Access Compliance Report

Public Rights-of-Way

(Curb Ramps)

Intersection ID: 10025341	Main Street: E_7TH_ST	Cross Street: N/A	Location: E
ADA ID: 195B08E4B294	Ramp Type: Para	Initial Pass/Fail: Pass	Overall Compliance: No
Severity Score: 0			
Codes/Mitigation Info/Possible Solution		Field Measurements/Component Compliance

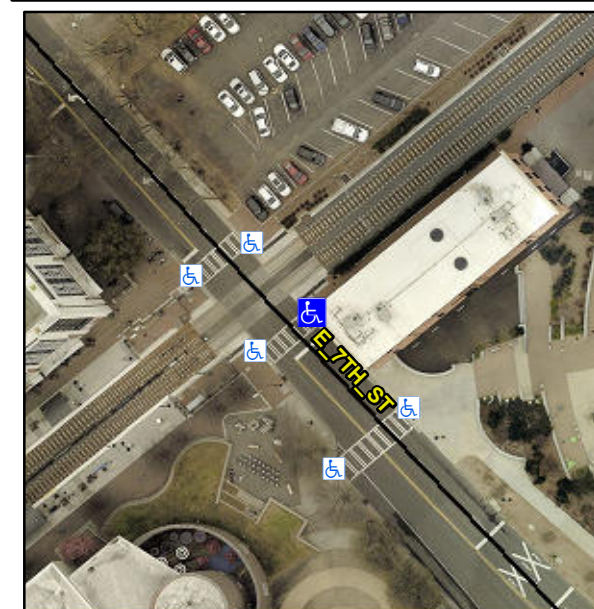
Surveyor Notes:

RT RP < 5%

PROW/ADA:

R304.2.2-Perp, R304.3.2-Para

Possible Solutions:

Remove & Replace Entire Ramp.
